Proposed 3D from the Hillside

Proposed 3D East Elevation

Proposed 3D from north-east

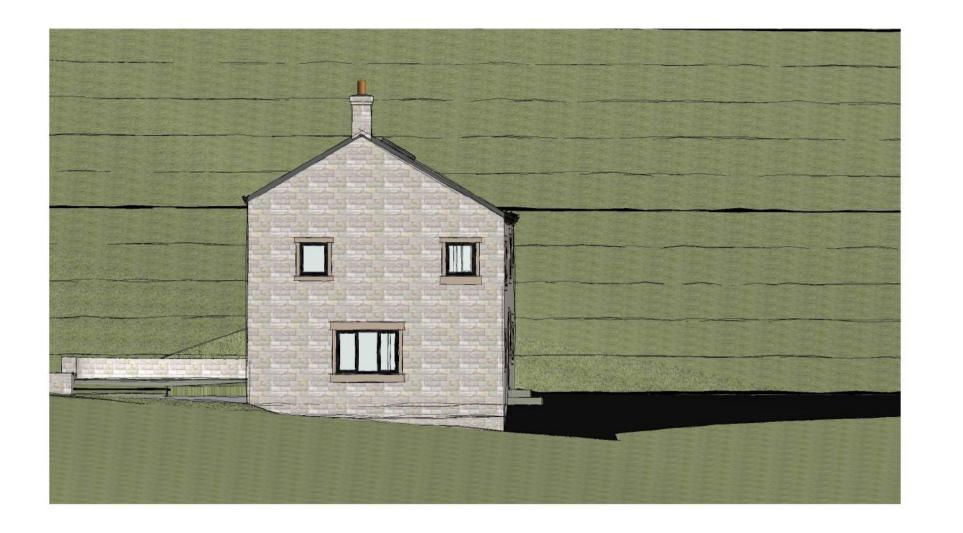
No.	Description	Date
Α	Amended following Plannings comments on previous application	29/06/16
В	Removal of glazed barn door	26/09/16
С	Addition of a first floor window to south elevation	31/10/16
D	Removal of additional first floor window and relocation of rooflight in south elevation	13/02/17
E	Relocation of rooflight in north elevation	05/04/17
